VILLAGE OF MORTON GROVE
Zoning Board of Appeals
FLICKINGER MUNICIPAL CENTER
6101 Capulina Avenue, Morton Grove, IL 60053
January 20, 2020 - 7:00P.M.
AGENDA

Re: **ZBA 20-02 – 9131 New England Avenue**
Request for approval of an expansion of a principal structure on a lot with non-conforming area and width, and a request for waivers from Sections 12-4-2 and 12-2-6 to legalize a non-conforming side yard and driveway width, after the fact

STAFF REPORT

PROPOSED GARAGE = 480 SF

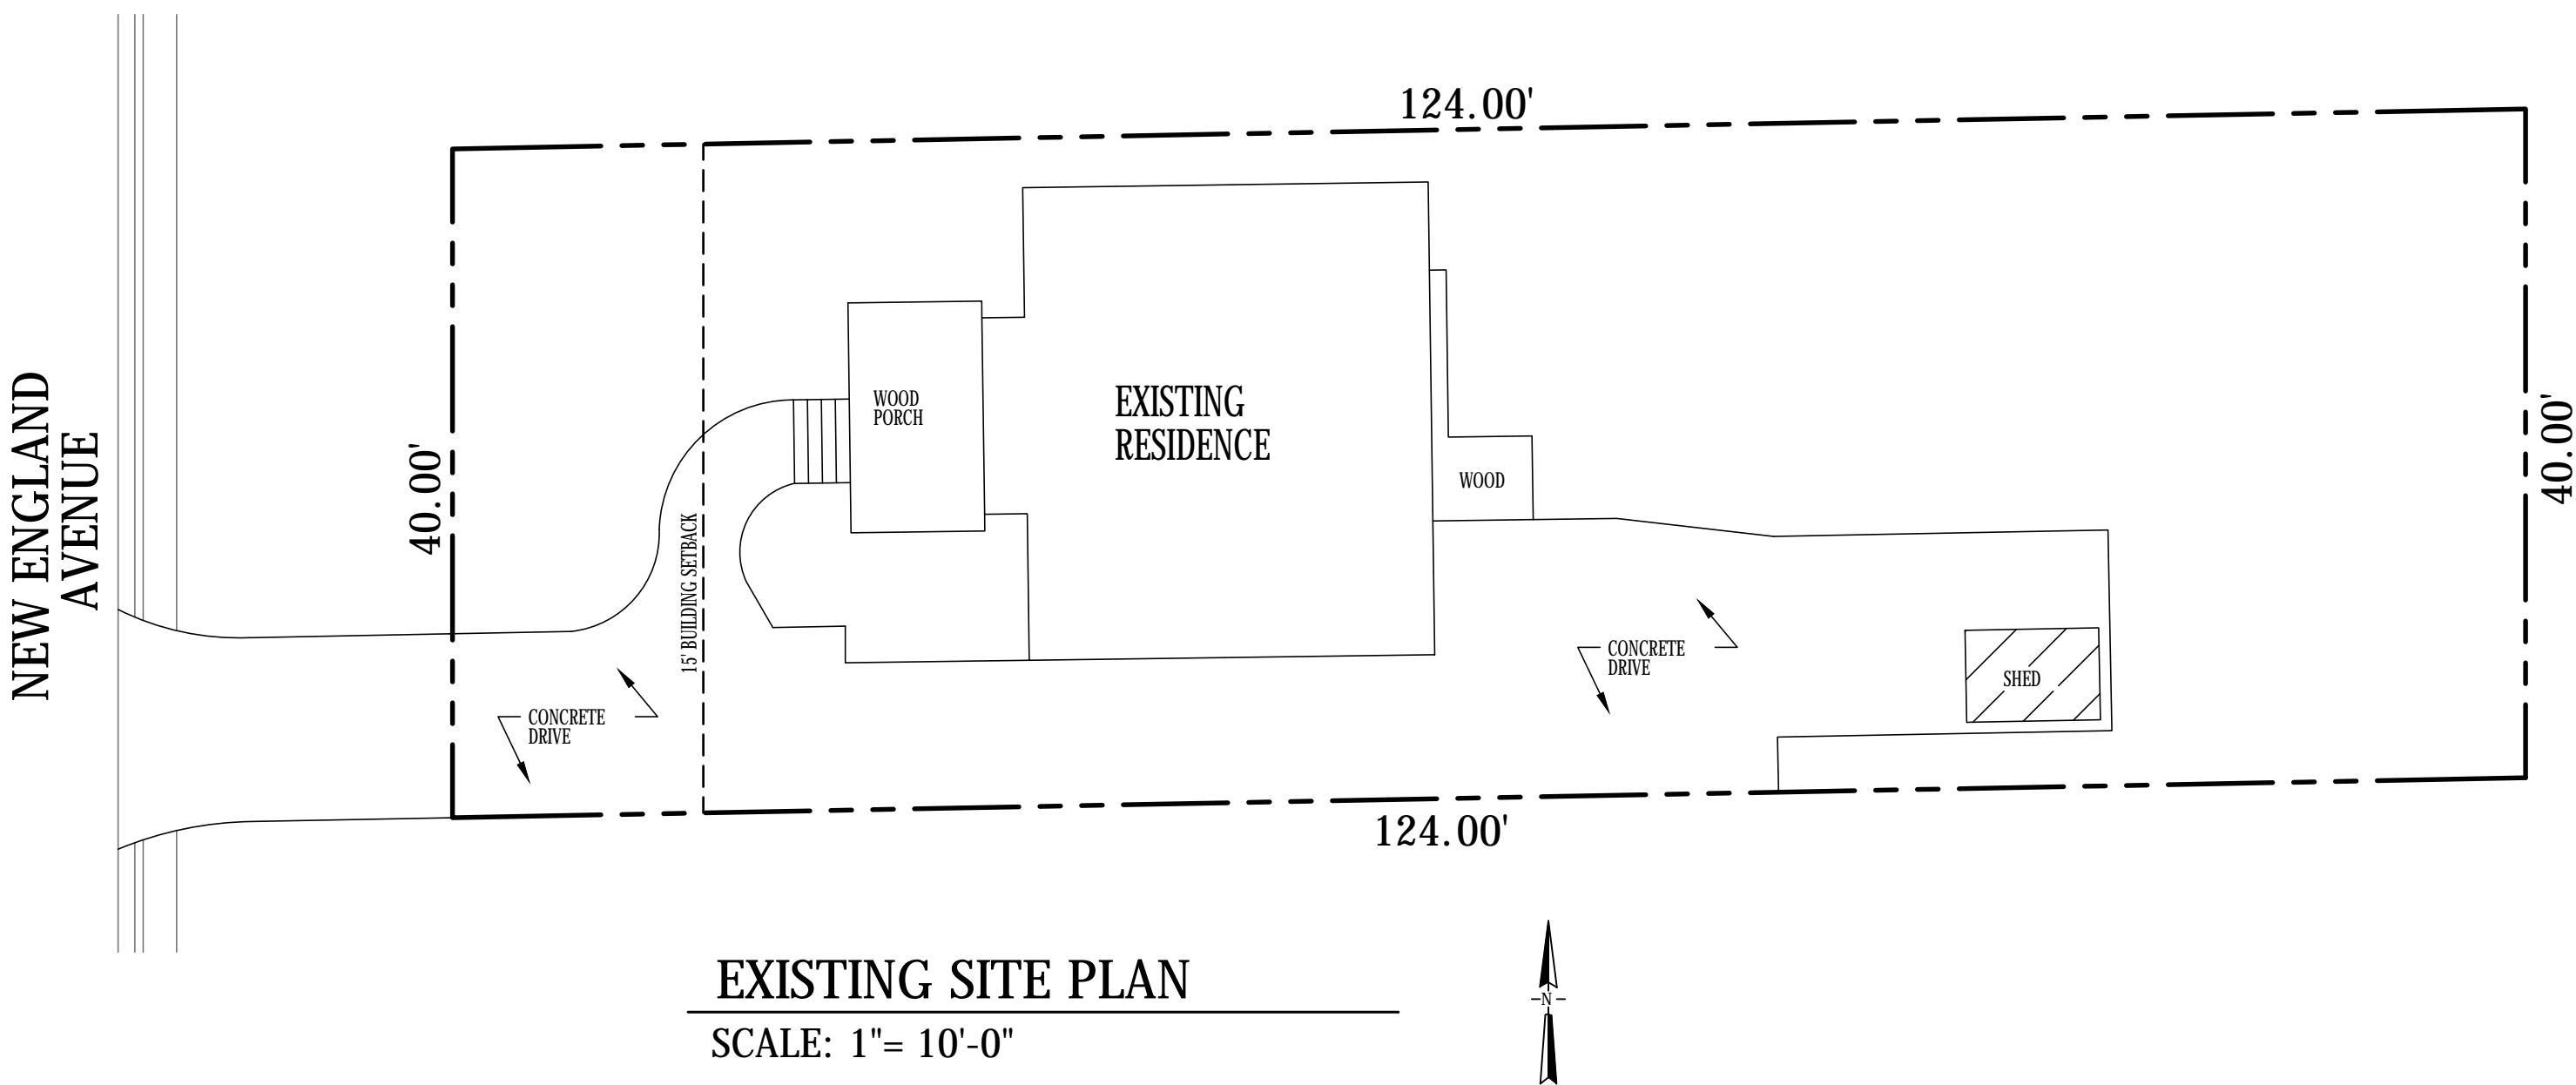
Staff's sole concern with the submitted site plan is the proposed concrete area located within the front yard. Per Section 12-2-6:G, sidewalks may be a maximum of 4 feet in width within the front yard. The applicant has agreed to reduce the width of the sidewalk within the front yard to no greater than 4 feet, which will result in a front yard plan similar to the one prepared by staff below. The yellow area illustrates where a compliant driveway and sidewalk may be placed. The red area illustrates the area of impermeable coverage that will need to be removed from the proposed plan to attain compliance. The final sidewalk design will be worked through in the formal building permitting process.

- 1) The proposed addition shall be built in accordance with the plans submitted by the applicant in the Variation Application dated 01/13/2020, except that the proposed walkway within the front yard shall comply with dimensional standards established in Section 12-2-6:G, Permitted Obstructions; and*
- 2) The applicant shall file all necessary plans and applications, for review and approval, and secure all necessary building permits prior to the commencement of construction.*
